Reply to Submissions

MP 08-0148 Sandy Beach Mill

A reply with respect to all submissions
to the exhibition of the Environmental
Assessment.

Ref: SJC1184-417
Date: June 2010

Plan 6.1 Figure 1 from Crown Land Submission

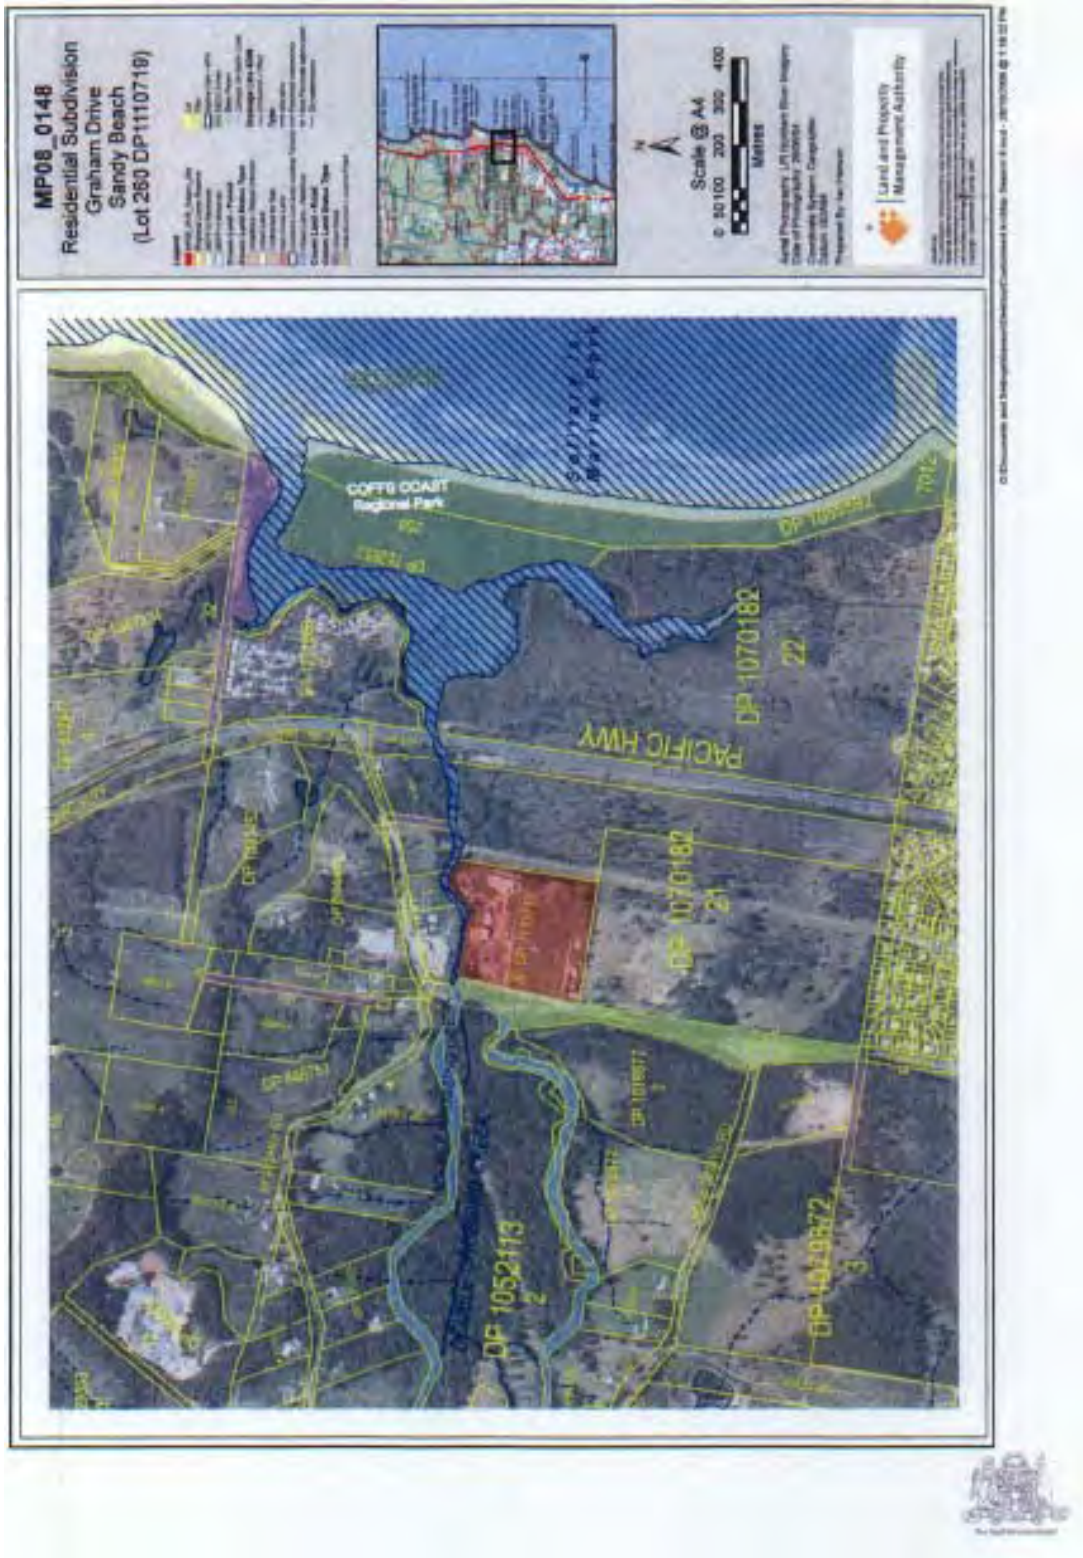
- As previously advised, the LPMA supports the establishment of a minimum buffer to Double Crossing Creek.
- It is noted a bioretention basin, playgrounds, half basketball court, picnic shelters, a local road and a 20m-wide asset protection zone' (APZ) are all located within the buffer to the RL 3.5 Australian Height Datum (AHD) contour. The placement of the bioretention basin within the buffer appears inconsistent with the provisions of the 'Hearnes Lake Estuary Management Plan' (EMP) and 'Hearnes Lake/Sandy Beach Development Control Plan' (DCP). Additionally, the DCP distinguishes between buffers and environmental protection areas (that is, buffers are not included in environmental protection areas, which, under the DCP, are synonymous with the buffer to the RL 3.5 AHD contour).

Comment
